Architect's Supplemental Instructions

PROJECT: *(name and address)*
Wilma P. Mankiller Health Center
Expansion
Stilwell, OK

ASI INFORMATION:
ASI Number: Bid Package 01 - ASI 002

Bid Package 01- ASI 02 – Wilma P. Mankiller Health Center Expansion

B4 ROOF FRAMING SECTION
SCALE: 3/4" = 1'-0"

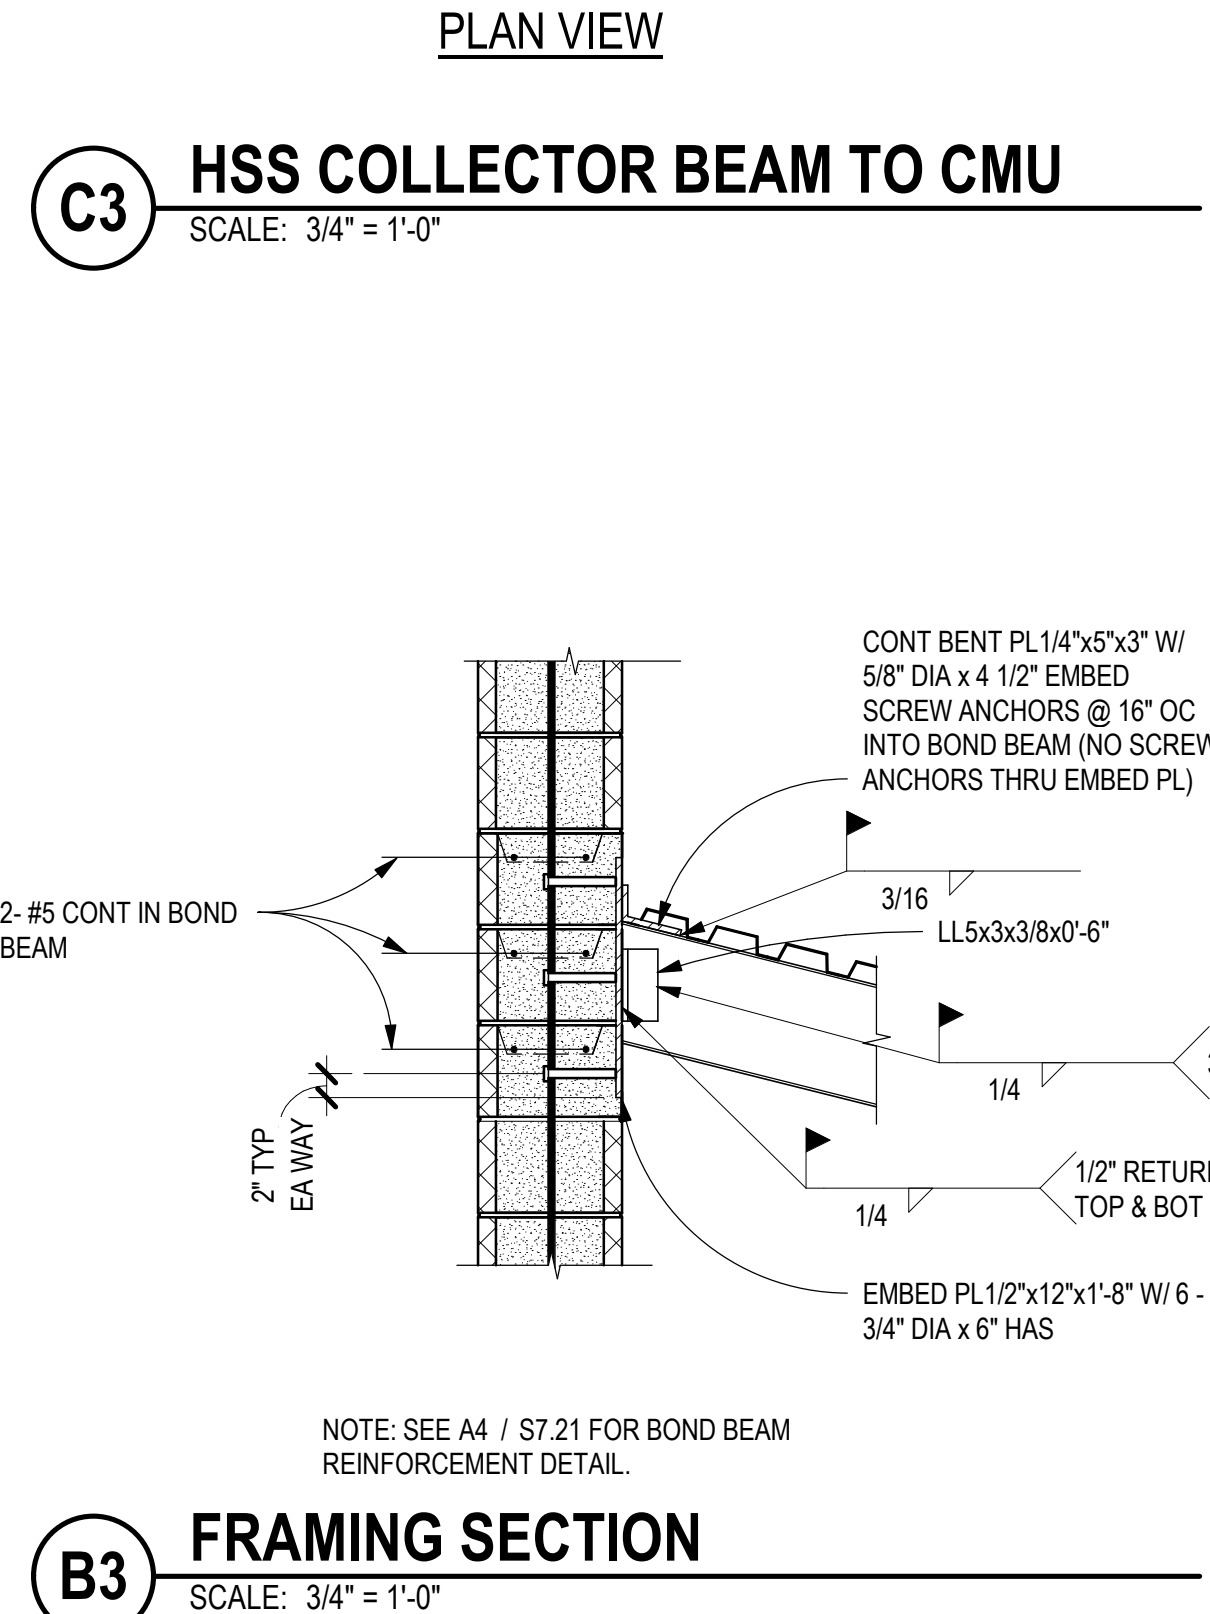
<u>Sheet</u>	<u>Description</u>
S1.13	Sheet keynote 12 removed from Grid 10.
S1.13	Section C1/S3.31 cut along Grid 10.
S1.13	Framing and deck edge near Grid G/10 modified.
S1.21	Beam sizes updated along Grid 10, between Grids G and D.
S1.21	Section C1/S3.31 cut along Grid 10.
S3.31	Section C1 added.
